SOUTH CAROLINA ELECTRIC & GAS COMPANY

June 3, 1982

Subject: Virginia C. Summer Nuclear Station
Docket No. 50/395
Control Room Ventilation System

Roof Plan Unit 1
 Figure 1.2-26
 (GAI Ref. E-001-062)

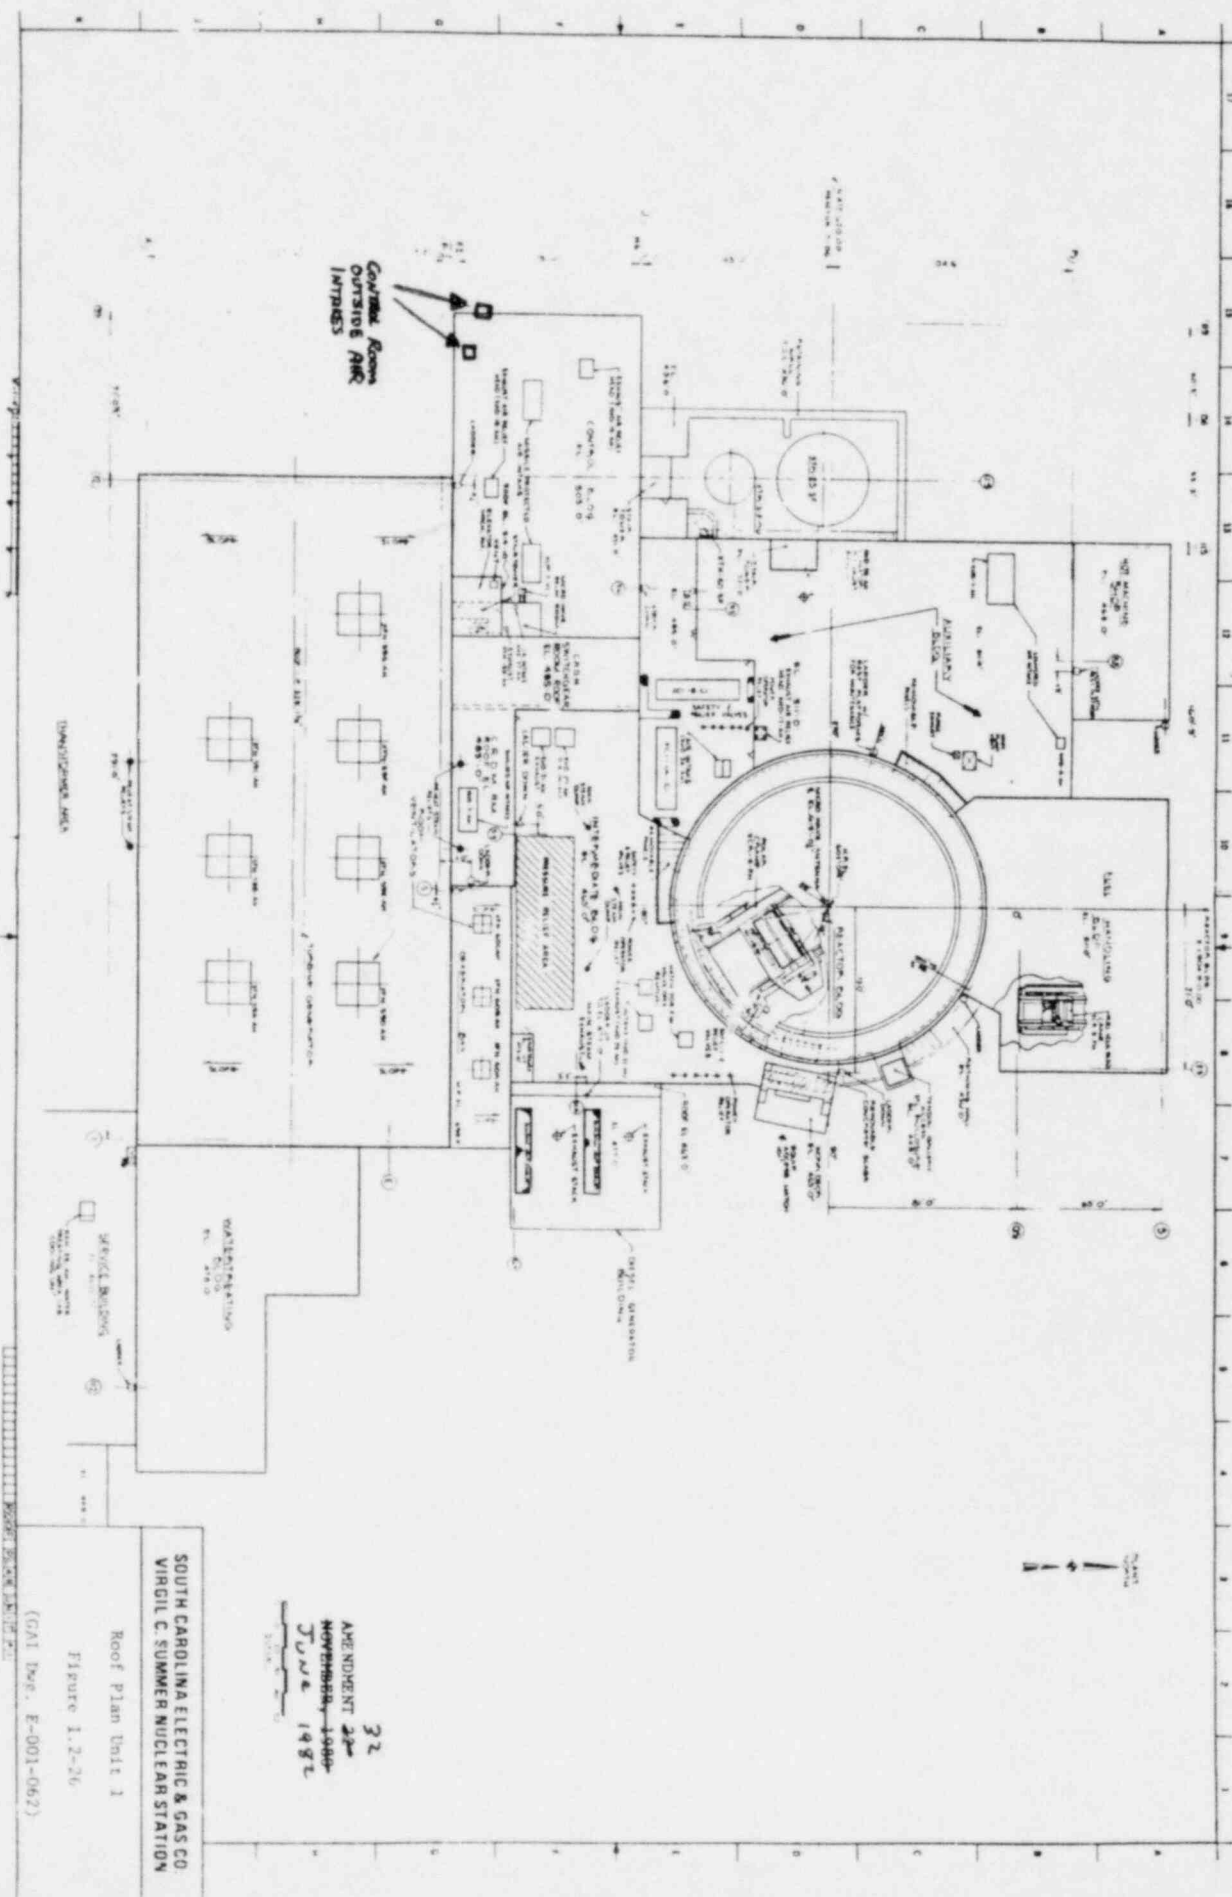
To ensure maintenance of 1/8" water gage positive pressure in the control room, South Carolina Electric and Gas Company has made two changes. One, we have modified the HVAC system to relocate the intake for the control room ventilation system. Two, we have used site specific meteorological data in determining control room dose (Chapter 15.4 of the FSAR).

The resulting FSAR pages are provided to indicate appropriate changes. These will be incorporated in the next FSAR Amendment. Drawing D-912-140 is FSAR Figure 9.4.1.
